**Re:** 23 Howe Rd Special Permit # 129-16

# Consistency Ruling (#129-16) - 23 Howe Road

Severini Residence

# Approved Plans per #129-16

All Elevations

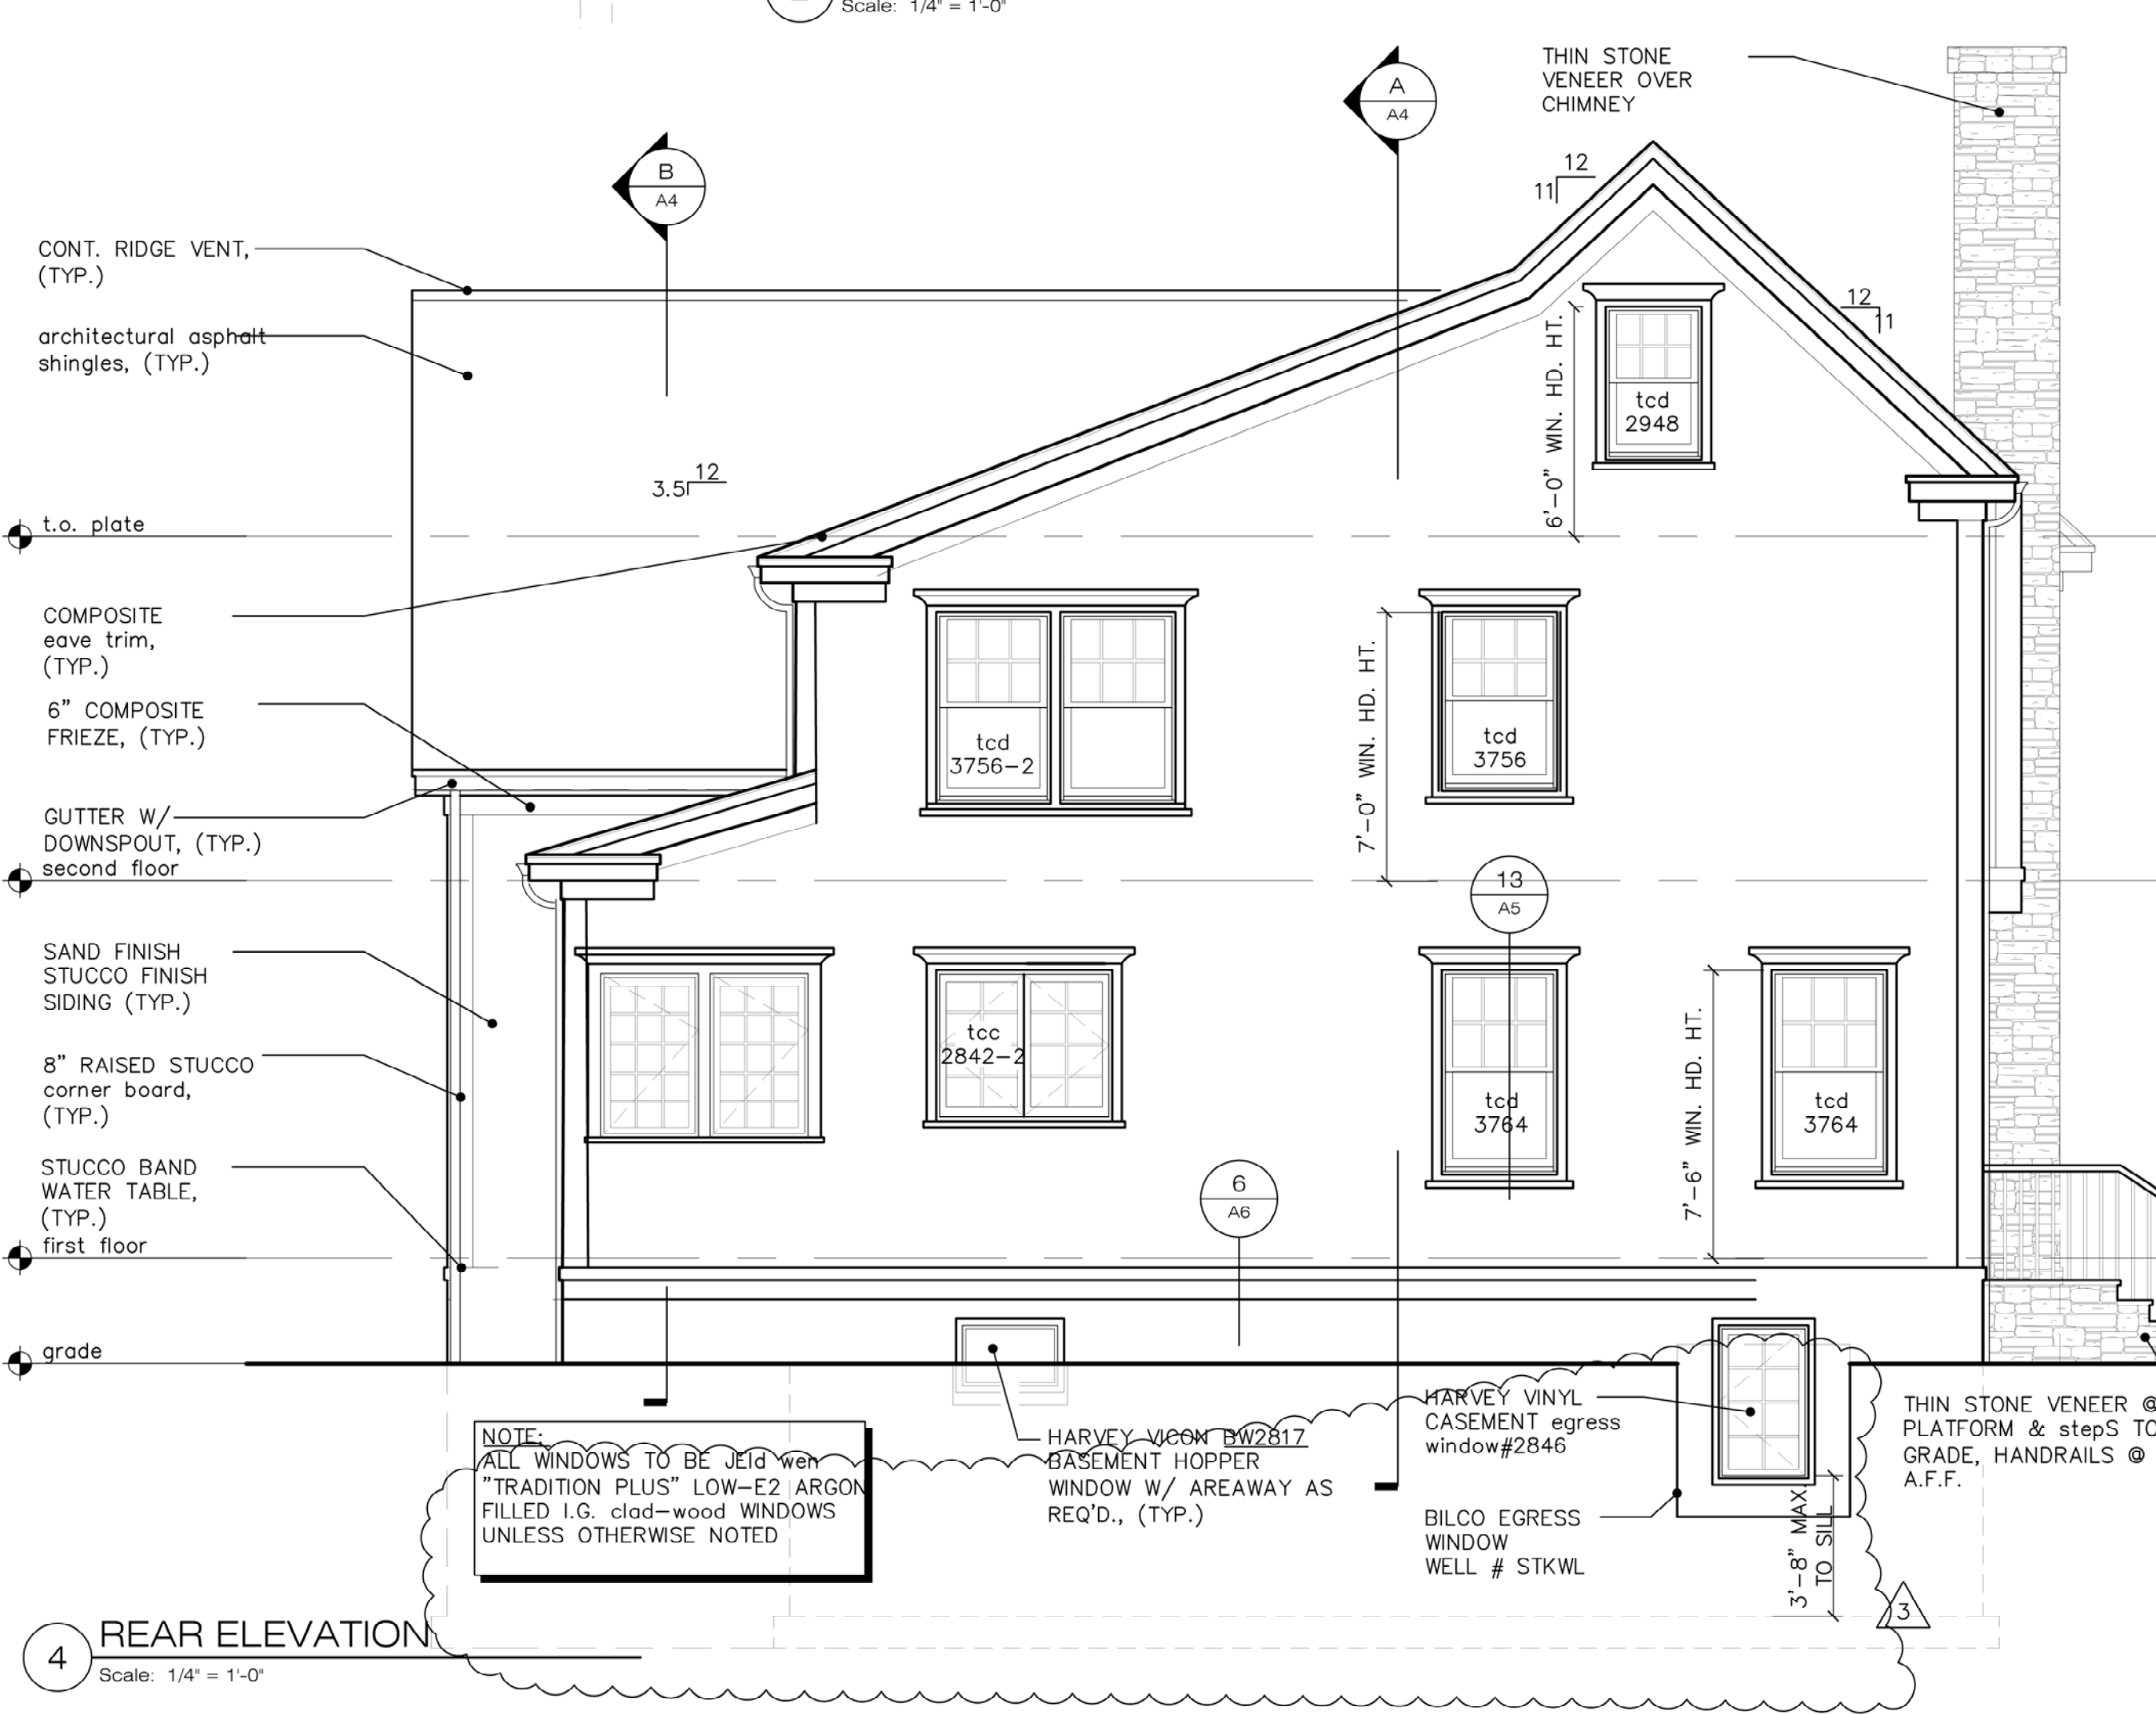
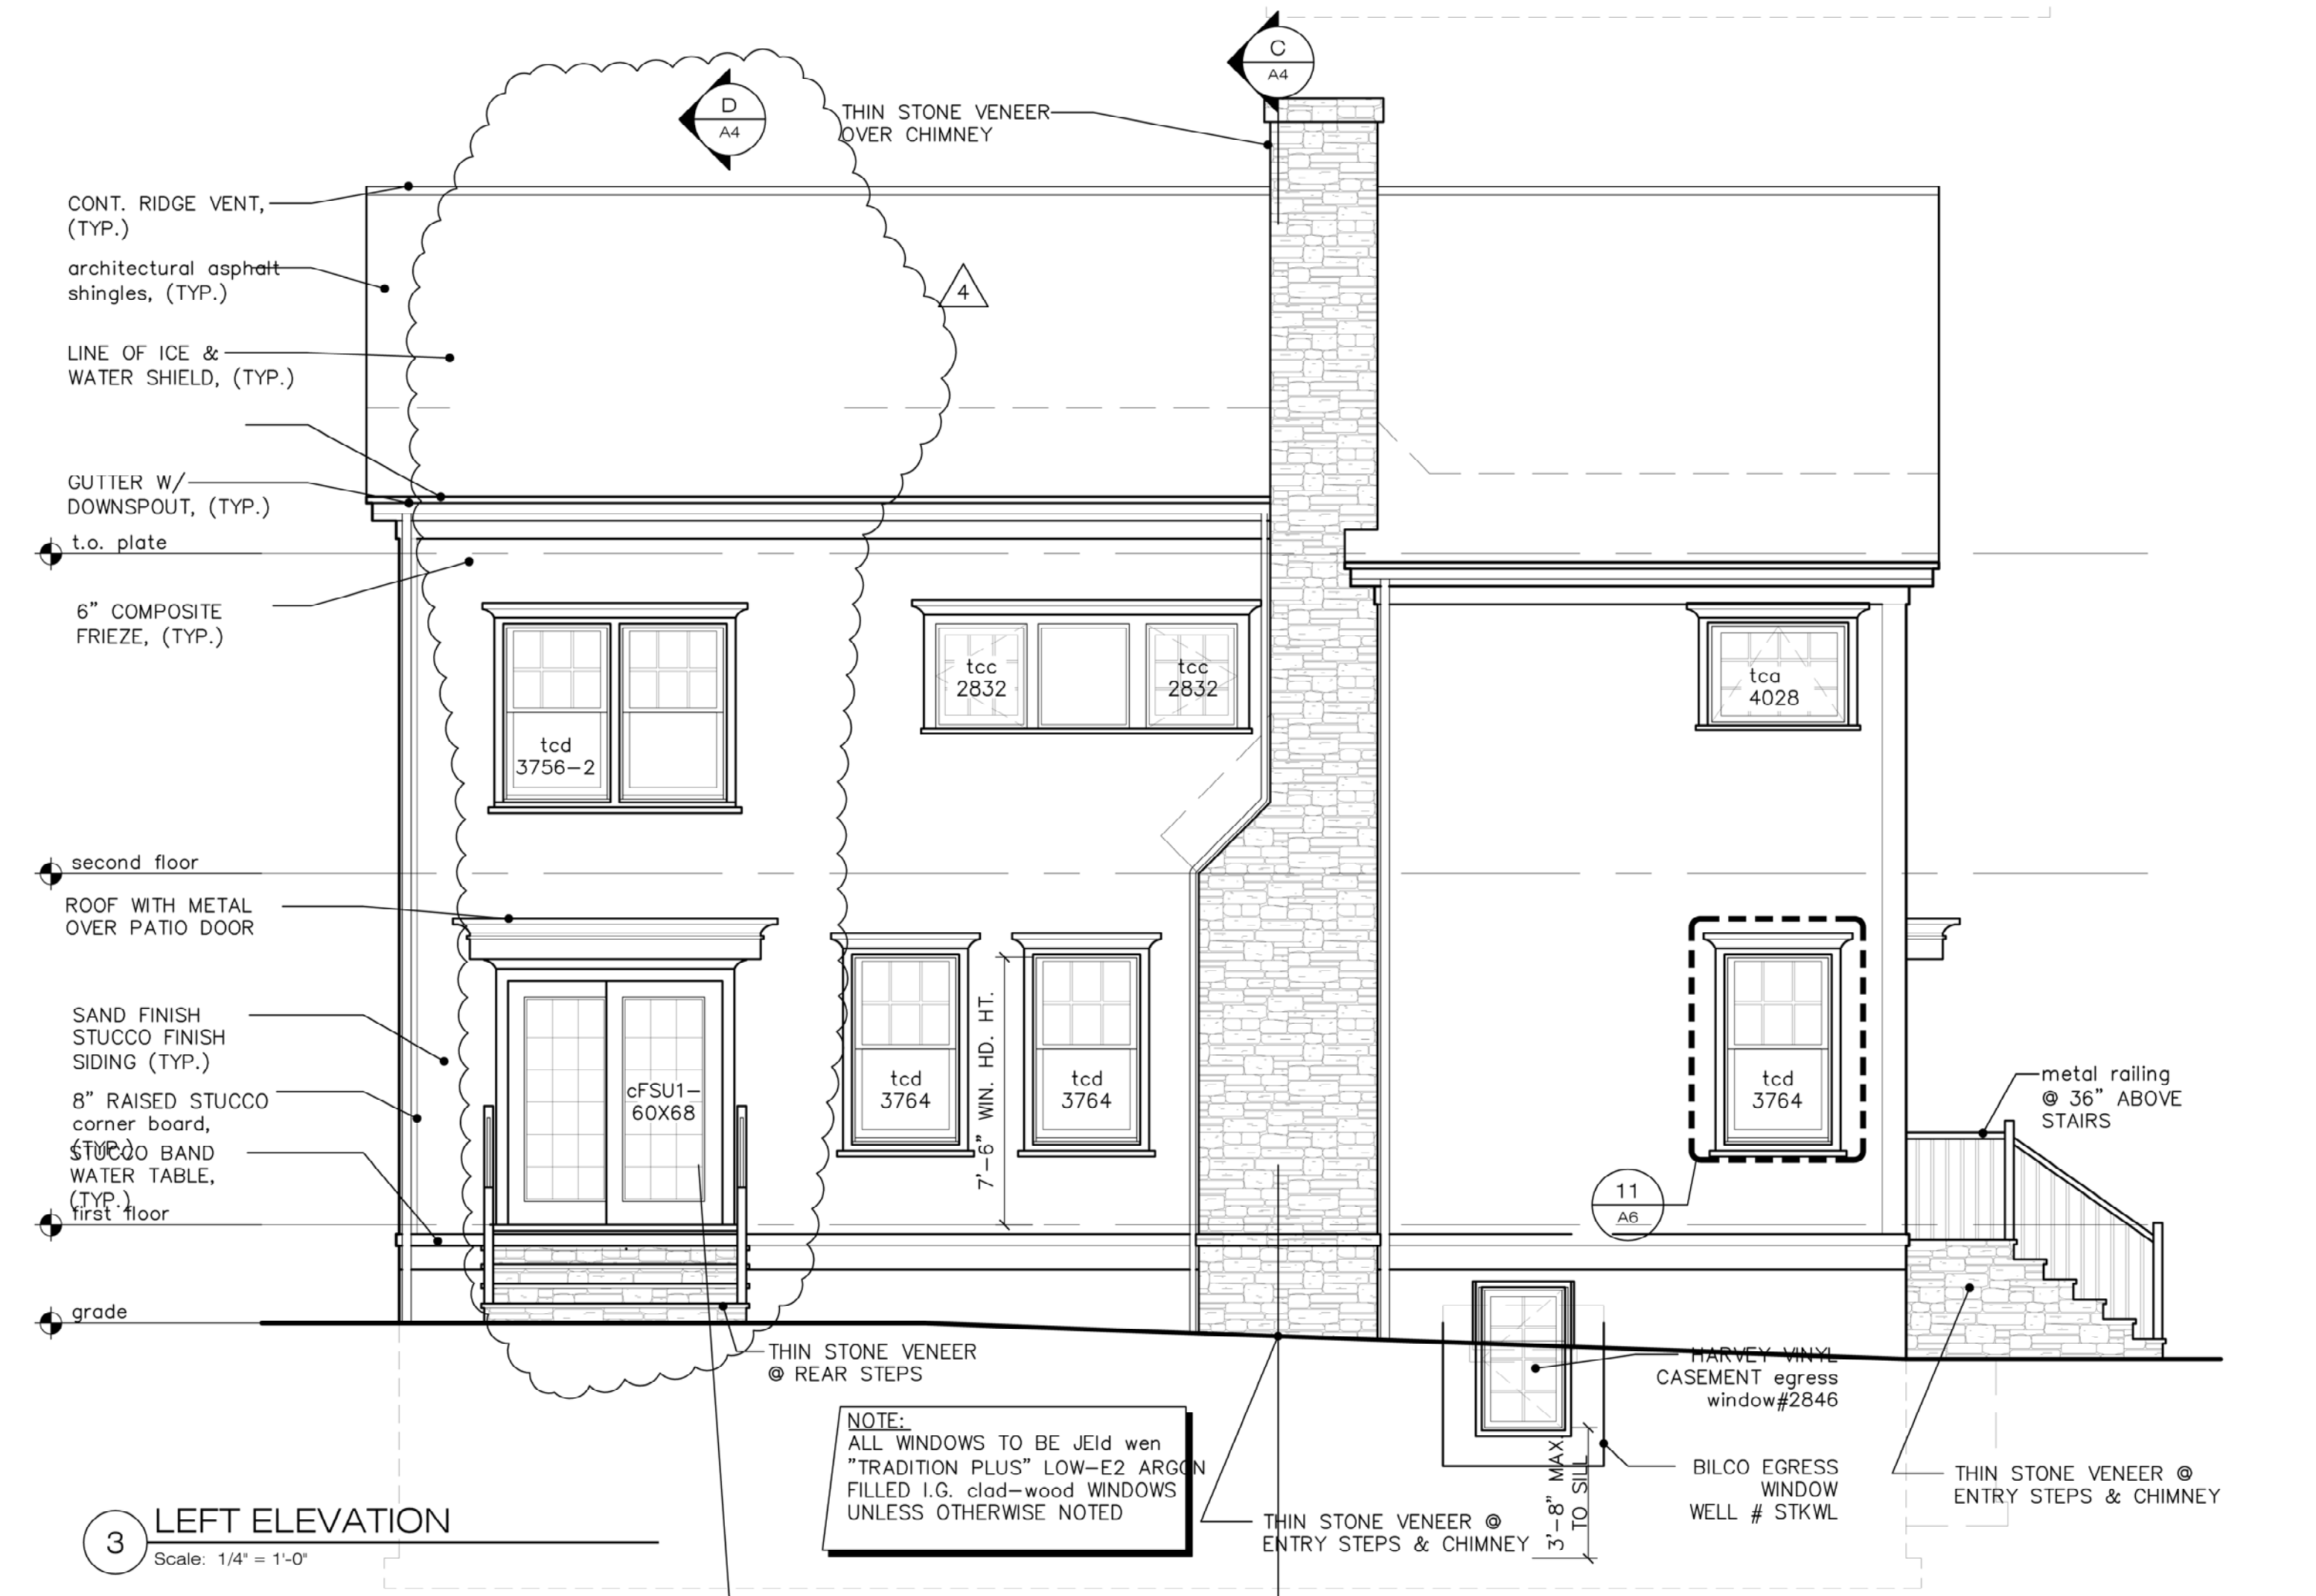
These revisions actually simplify the rooflines, remove all the dormers and any living space on the third floor. We used some of that square footage to add a small sunroom in place of a larger patio to the first and raise the roof over the kitchen, eliminating the kitchen volume ceiling in favor of adding living space in that area. The lot setbacks and height of the main ridge are unchanged. We reviewed the FAR chart and method for square footage with Anthony Ciccariello to make sure we were counting the areas properly.
